**RHODE ISLAND COASTAL RESOURCES MANAGEMENT COUNCIL
REPORT OF FINDINGS -- PRELIMINARY DETERMINATION**

NAME: W. Mark Russo (Special Master) Noble Development, LLC **CRMC FILE NO.** 2021-01-027

LOCATION: Roger Williams & Borne Avenue(s)

PLAN(S) REVIEWED: "Map 203 Block 1, Lot 4, Roger Williams Avenue, East Providence, Rhode Island – Site Plan", in two sheets, site plan (coastal side) and site upland (upland side), by Northeast Engineers and Consultants, Inc., dated 11Jan21.

**APPROXIMATE LOCATION
OF WETLANDS**

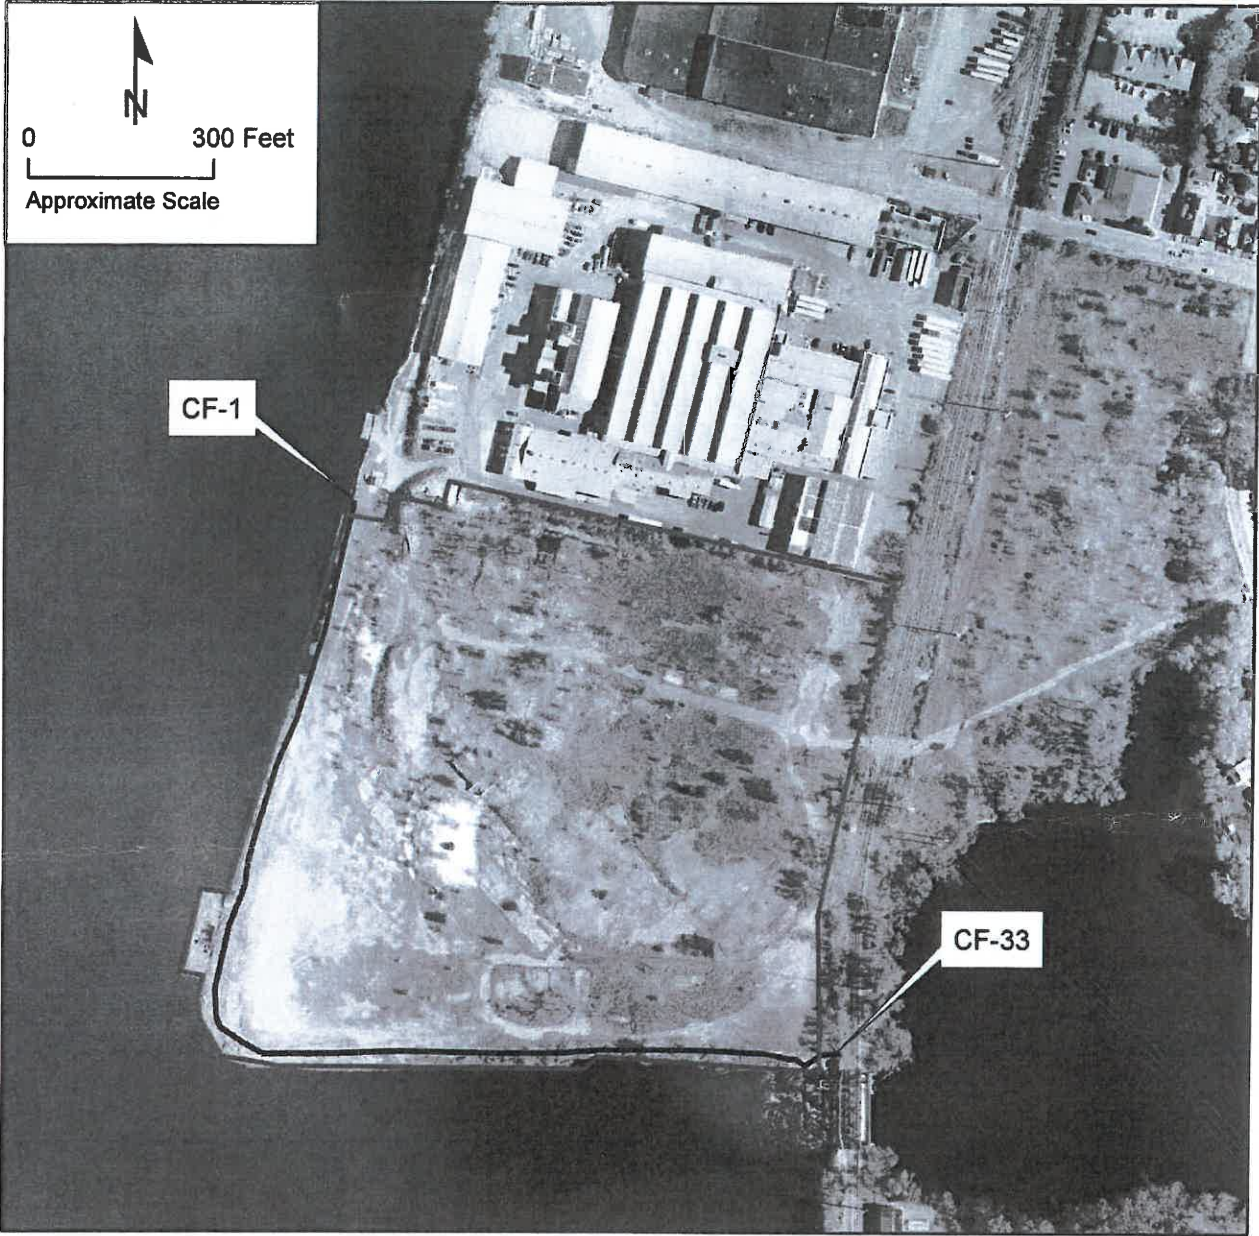
2. **Coastal Feature and Wetland Edge Verification:** The coastal feature and wetland edges of regulated resources have not been verified as part of this Preliminary Determination review. However, based on CRMC Staff knowledge of the area and review against the plans contained in CRMC File No. 2007-02-058, the coastal feature delineation appears to be sufficiently accurate for review and project permitting. It should be considered that the inland edge of the coastal feature on the “coastal” (Seekonk River) side is considered to be the top of the manmade fill slope. This manmade slope is not considered to be a coastal bluff or bank. In some areas, the lower portion and bottom of the fill slope is inhabited by coastal wetland plant communities and is considered “coastal wetland”. The freshwater wetland edge on Omega Pond requires future verification. The wetland edge in the vicinity of flag A13 appears to be of concern,
